Corrigendum to “Ducted wind turbine optimization and sensitivity to rotor position” published in Wind Energ. Sci., 3, 221–229, 2018

Published: 16 August 2018

Figure 7. Streamlines of design for optimal C_p .

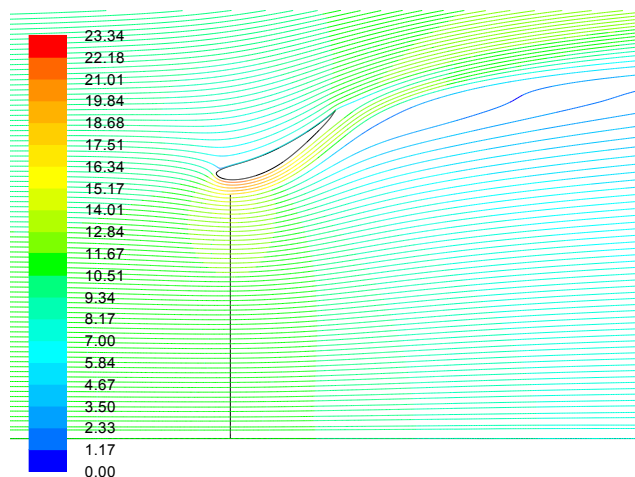
The wrong Fig. 11 was published in the paper (Fig. 8 was reprinted again as Fig. 11). The correct Fig. 11 is given below. Additionally, as Fig. 7 did not show the actuator disc completely, it is reproduced again here so that the geometries may be better compared.
